### PHOTOGRAPHS

#### **BUILDING 6 SECTION A**

**PHOTOGRAPH #1**

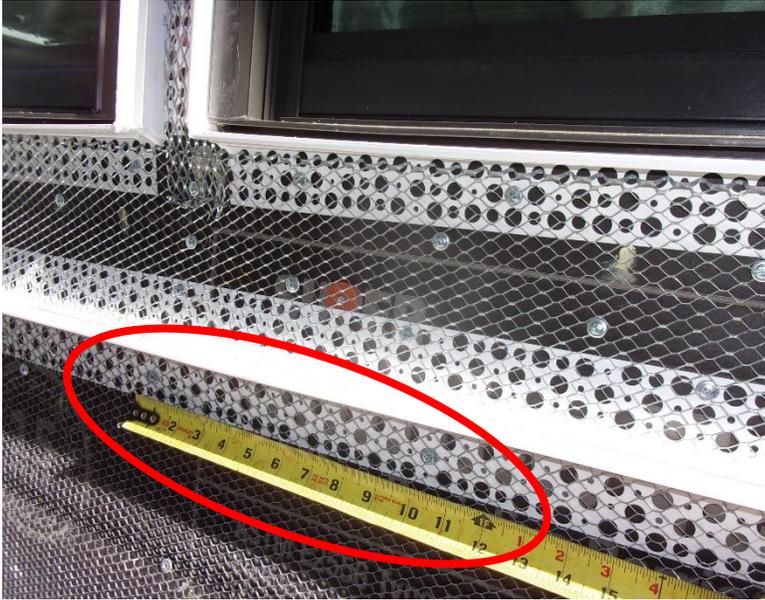
Sub-contractor lacked fasteners at attachment of vinyl accessories. Specification requires attachment at minimum of 7" O.C.

**PHOTOGRAPH #2**

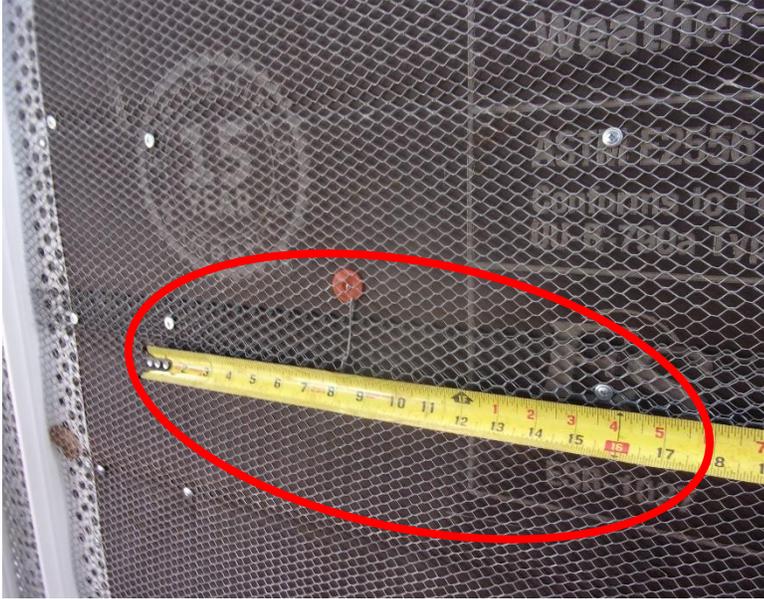
Contractor adding missing fasteners at vinyl stucco accessories to meet the specified minimum of 7" O.C.

**PHOTOGRAPH #10**

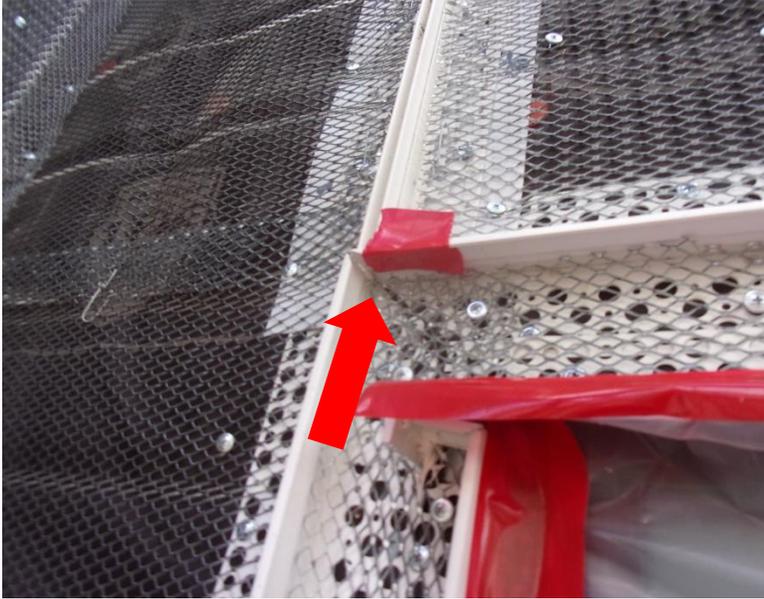
Sealant missing butt joints and transitions of vinyl accessories.

Missing sealants at butt joints and transitions of vinyl accessories corrected by sub-contractor.
